# **Statement of Response to Pre-application Consultation Opinion**

## **Mixed-use Development**

**Lands West of Old Belgard Road and North, South & West of  
Cookstown Road, Cookstown Industrial Estate, Tallaght,  
Dublin 24**

**February 2021**

Figure 2.0 Phasing proposal outlined in Drawing No. P19127-CWO-00-00-DR-A-0015, prepared by C+W O'Brien Architects

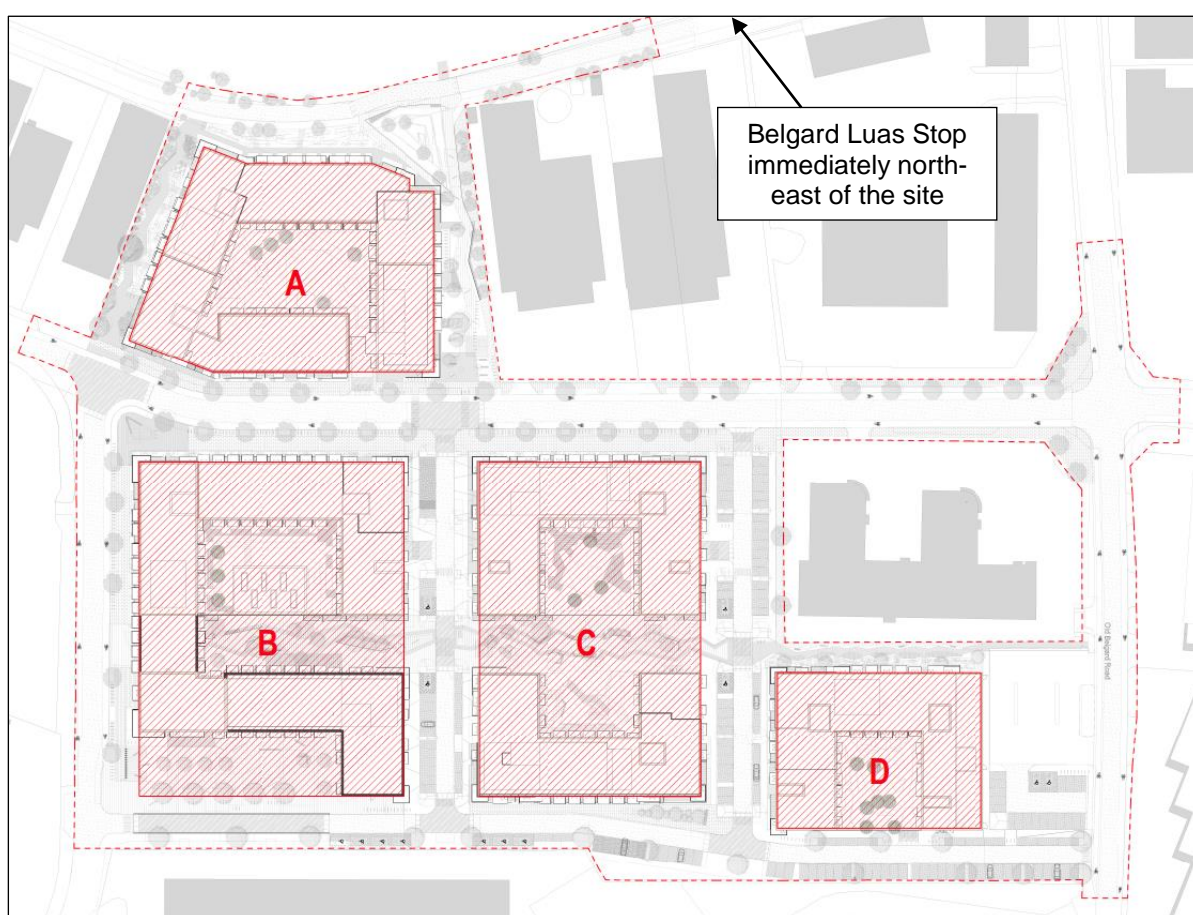
- 1. Further consideration of the documentation as it relates to the integration of the proposed development with the regeneration of adjoining sites and the rest of the industrial estate. The documentation should demonstrate whether and how the proposed development could form part of a coherent and sustainable regeneration of the area with regard to the layout, design and height of the proposed buildings; the number, size and type of the proposed residential units; open space; and the mix of uses including the provision of supporting social and commercial services including childcare. The documentation should address the provisions of the development plan including its core strategy, and any local area plan or other planning framework that had been adopted by the planning authority before the application was made.*

- The site benefits from immediate proximity to the Luas Red Line Station at Belgard and a new pedestrian linkage to this station (provided with the consent of Dublin City Council) will be delivered in Phase 1 of the proposed development providing a significant planning gain for the coherent redevelopment of the area. It is envisaged that the phasing of development will progress initially with those parts of the site that are nearest the station and will be completed, in time, with those elements that are more distant from the Luas stop, as illustrated in Drawing No. P19127-CWO-00-00-DR-A-0015, prepared by C+W O'Brien Architects (an excerpt of which is provided below at Figure 2.0).

Figure 10.0 Excerpt from Drawing No. NRB-TA-002, prepared by NRB Consulting Engineers, included at Appendix A of the Transportation Assessment Report

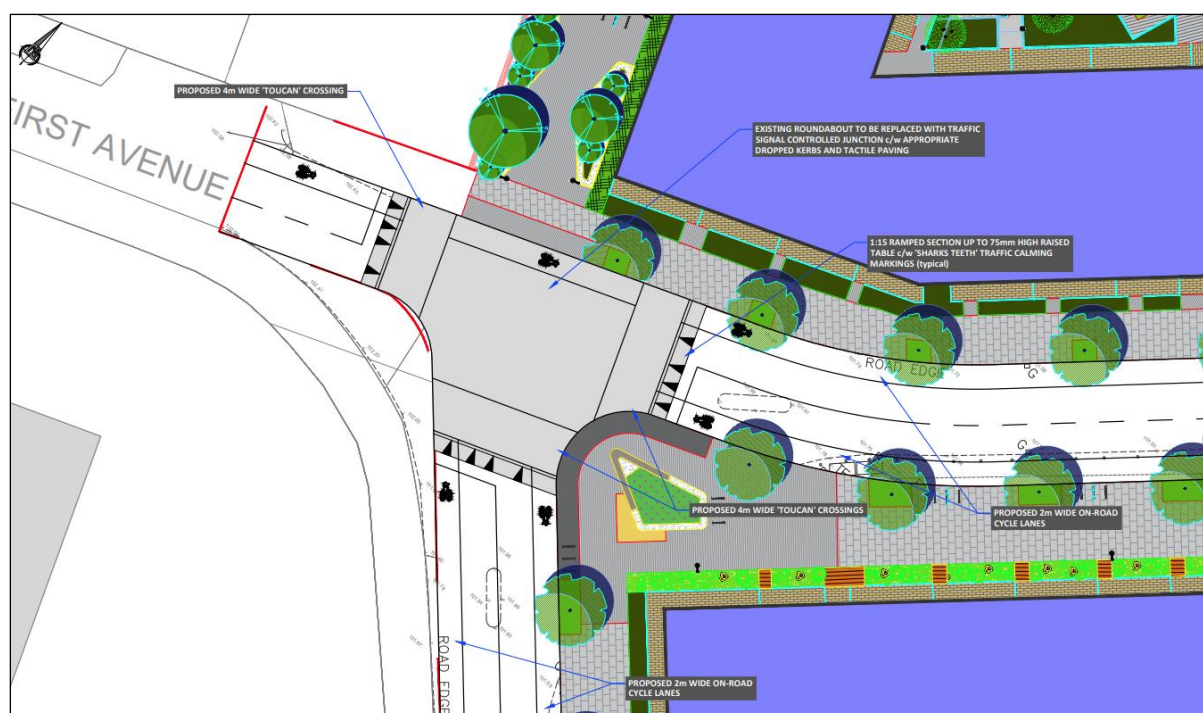
In terms of ***'If separate cyclist facilities are proposed, the documentation should demonstrate whether they would comply with The National Cycle Manual and provide proper priority for cyclists over vehicles existing from minor roads at junctions'*** we highlight the following:

- Proposed Cycle facilities on the Larger Public Roads are compliant with the National Cycle Manual (NCM) (NCM pages 12 & 83), with advance cycle facilities and Toucan type crossings incorporated into all signal controlled junctions. Internally, for the minor streets, the cyclists infrastructure is also consistent with the NCM (NCM Pages 54 & 55).
- Pedestrian and cyclist priority at minor roads, and associated traffic calming, is achieved through the use of raised platforms which afford priority to pedestrians and cyclists.

The cycle infrastructure proposed is best illustrated in the drawing excerpt included in Figure 10.0 below.
